EXHIBIT F

Firearms Technology Industry Services Branch

December 23, 2021

Franklin Armory, Model FAI-15, .45 Colt, Semiautomatic Rifle,
Serial Number A-12680

Franklin Armory, model FAI-15's rifled bore

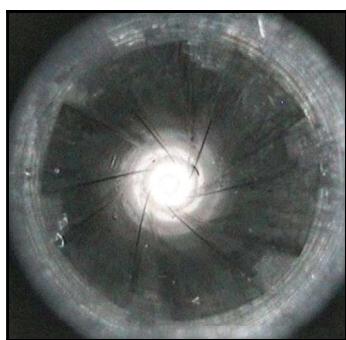
The submitted sample's barrel is approximately 14.5 inches in length. The barrel extension and the barrel breech are fit and chambered to accept the .45 Colt and .410 Bore cartridges. The bore of the sample's barrel is approximately 0.443 inch in diameter. The bore is rifled with six lands and grooves in a right twist with a major diameter of approximately 0.454 inch. The rifling present in the bore of the submitted sample is of sufficient depth and twist to impart spin to a projectile.

FTISB does not dispute the marketability of firearms chambered for dual cartridges. However, rifling is an objective design feature specific to firearms. Rifling is an objective feature explicitly designed to impart spin on a single projectile around its longitudinal axis. This spinning of a projectile stabilizes the projectile and improves its aerodynamic stability and accuracy.

While a weapon with a rifled bore that also fires shotshells may provide a commercial advantage, a rifled bore is disadvantageous as an objective design feature when using shot ammunition, as the twist of the shot column traveling down the bore will spread the shot pattern. This is the reason that a smooth bore is traditionally used for this purpose. The decision to market a firearm as capable of firing shotshells in addition to traditional single-projectile ammunition does not indicate that the weapon was “designed, made and intended” to fire other than a single projectile, only that a commercial advantage exists *in spite* of the objective design of the weapon. While any bore, including a rifled bore, may be *capable* of expelling multiple projectile ammunition, not all bores are *designed* to expel multiple projectile ammunition [emphasis added]. FTISB holds that a rifled bore is an objective design feature designed and made to fire only a single projectile.

The submitted Franklin Armory, model FAI-15 sample is a weapon designed, made, and intended to be fired from the shoulder. The submitted FAI-15 sample is designed and made to use the energy of an explosive to fire only a single projectile through a rifled bore. Therefore, the FAI-15 sample is a “**rifle**” as defined under 18 U.S.C. § 921(a)(7) and 26 U.S.C. § 5845(c).

Being a rifle having a barrel less than sixteen inches in length, the submitted Franklin Armory, model FAI-15 sample is a “**short-barreled rifle**” as defined under 18 U.S.C. § 921(a)(8) and a “**firearm**” as defined under 26 U.S.C. § 5845(a)(3).

The submitted sample is a “**short-barreled rifle**” under 18 U.S.C. § 921(a)(8) and a “**firearm**” as defined under 18 U.S.C. § 921(a)(3) and 26 U.S.C. § 5845(a)(3).
